IFB TITLE: Main Terminal HVAC Rehabilitation at the Jack Brooks Regional Airport

ADDENDUM NO.: 1

ISSUED (DATE): January 31, 2023

Reason for Issuance of this Addendum: CLARIFICATIONS

M2.03A

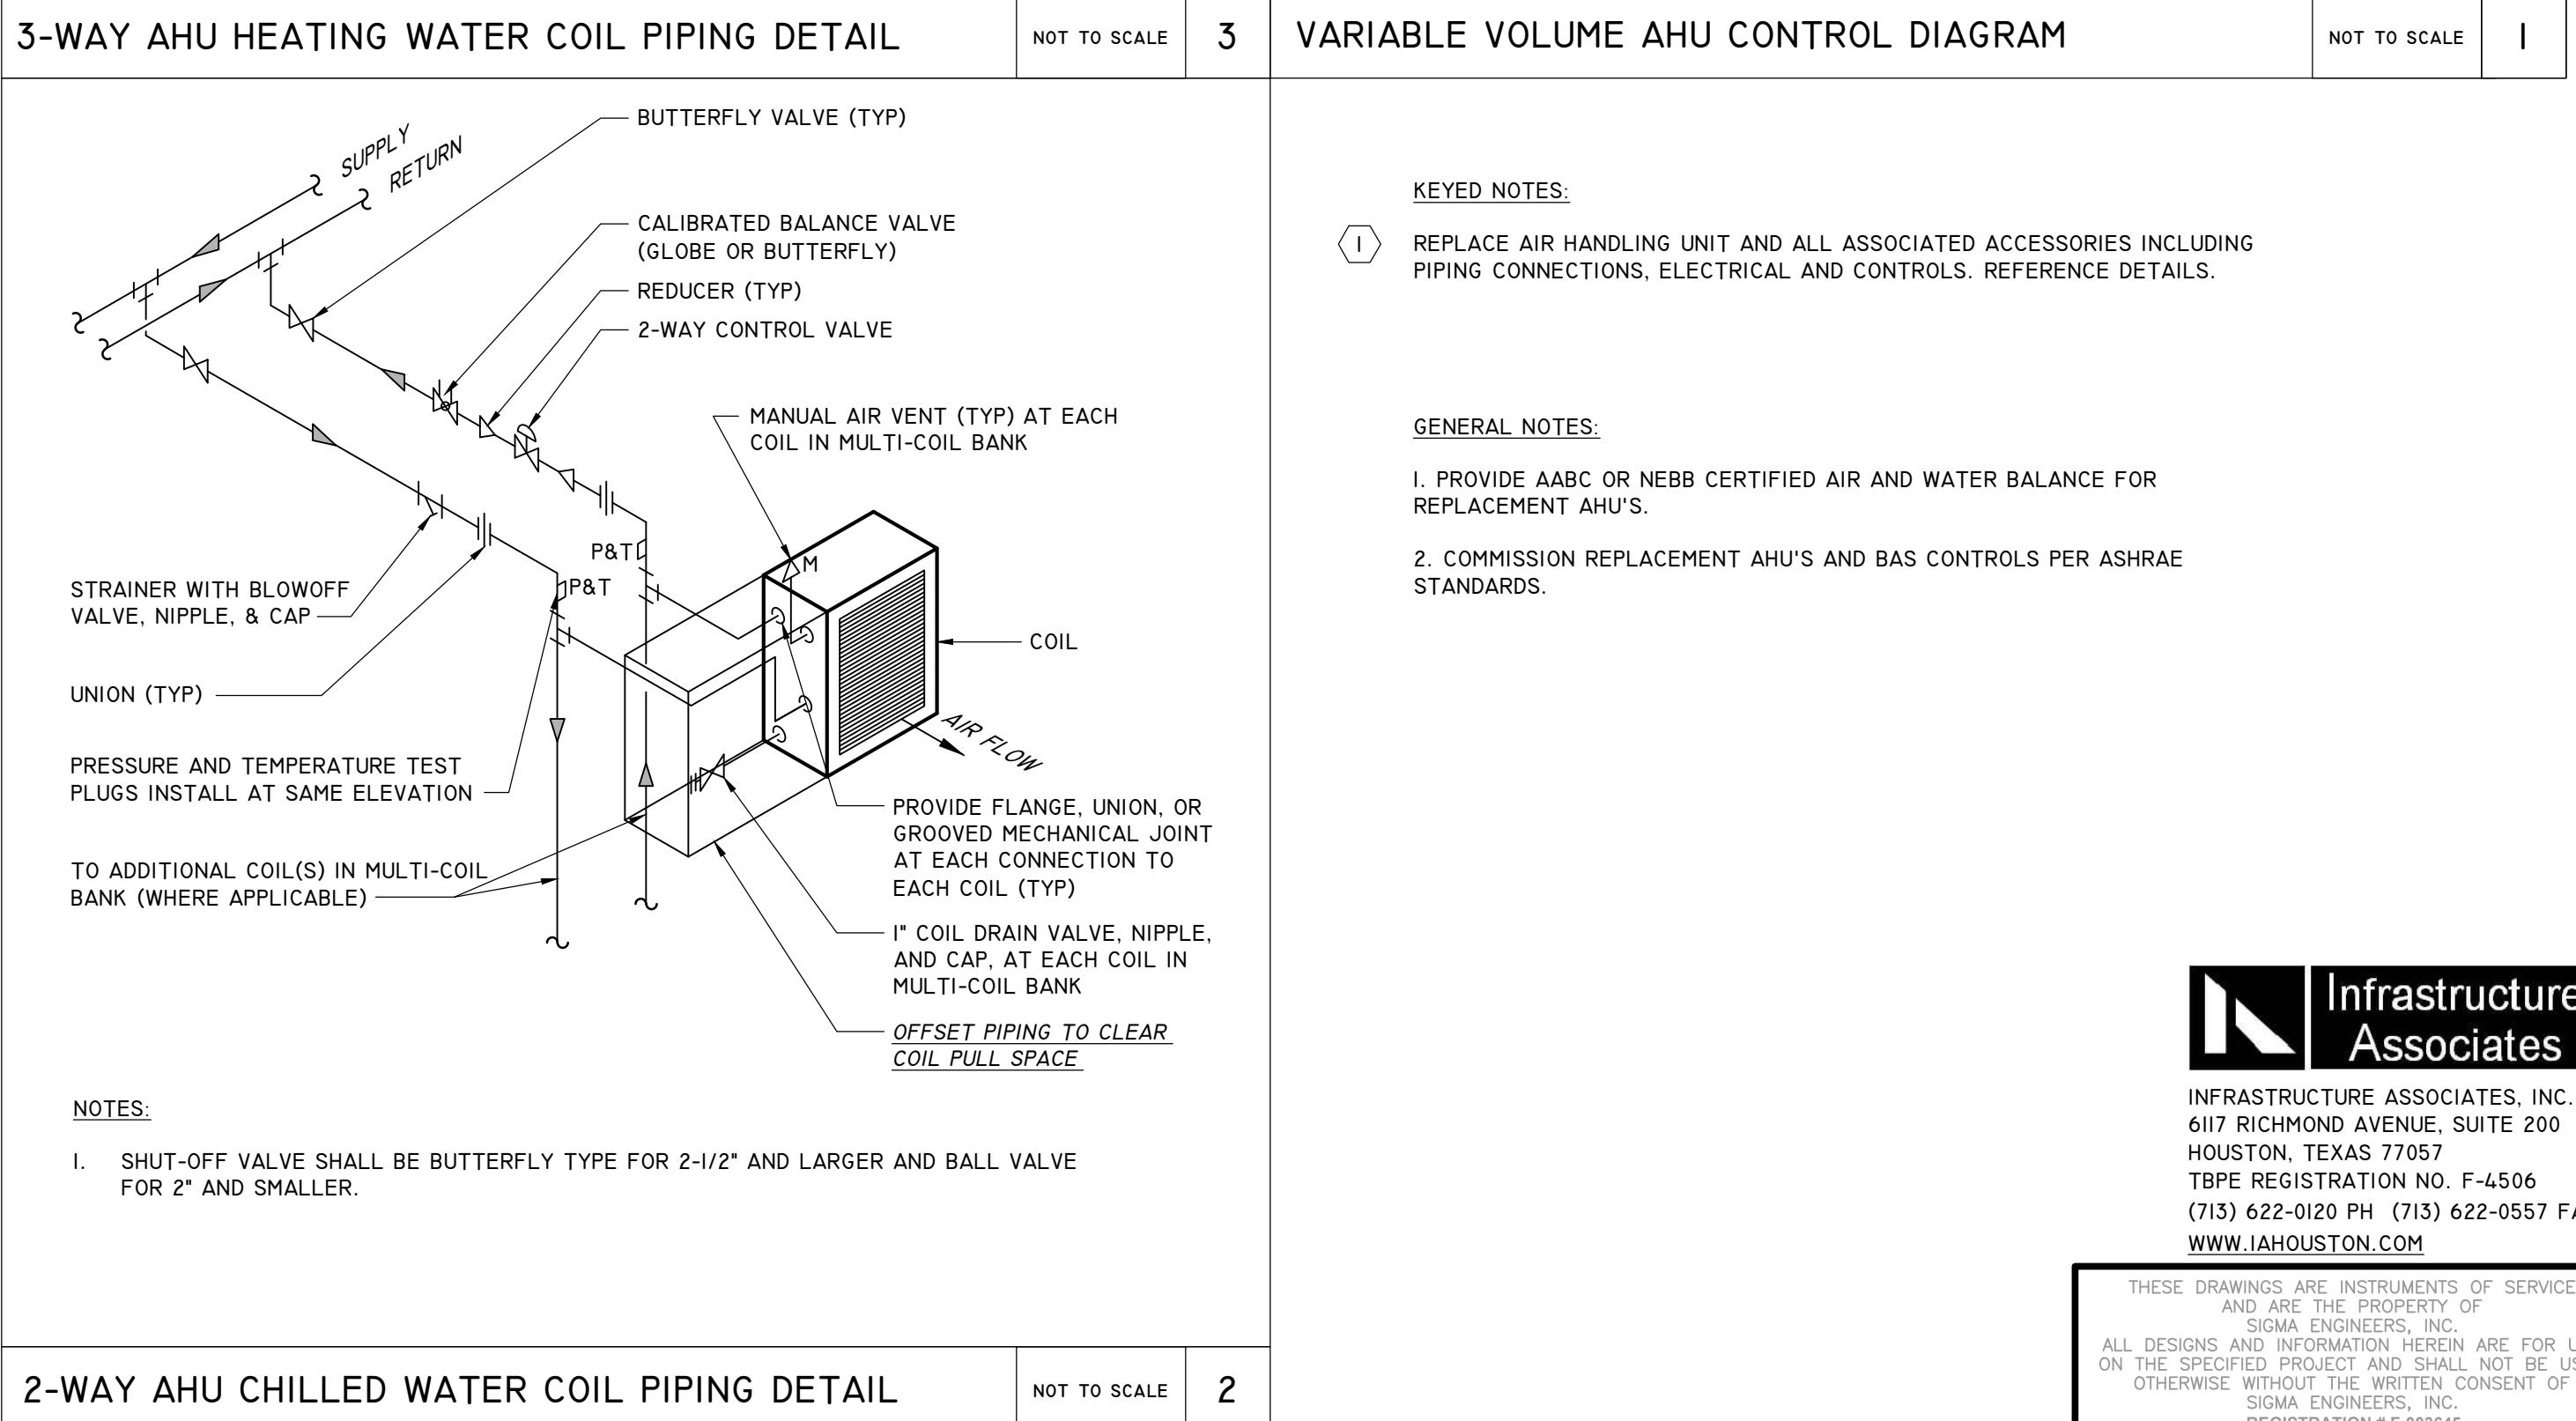
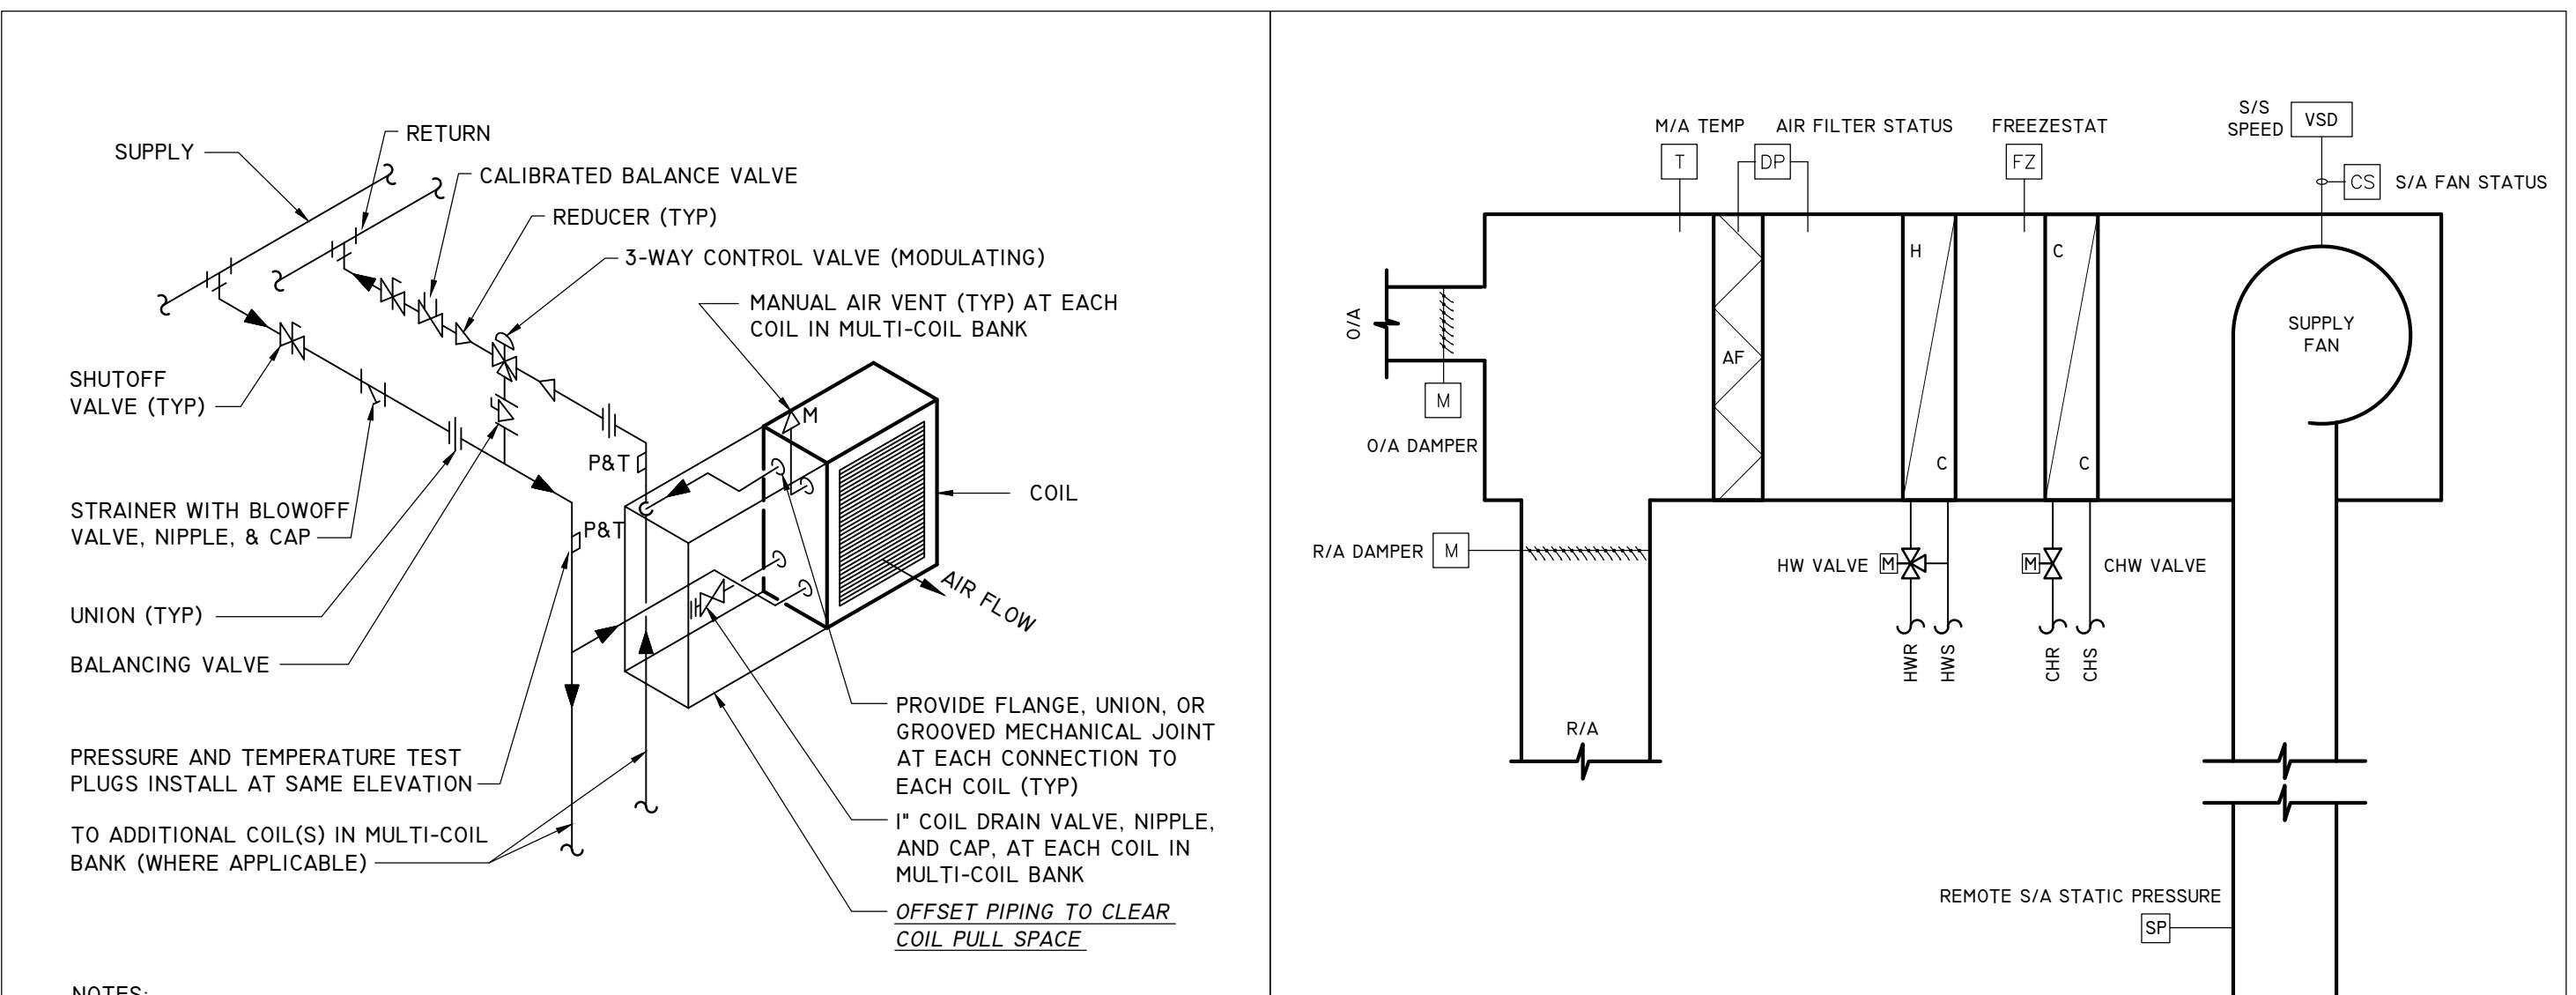
10. Enclosed you will find drawing M2.03A. Air handler units 1 – 7 are to be replaced per Alternate #1. (See Addendum No. 1: Attachment A)
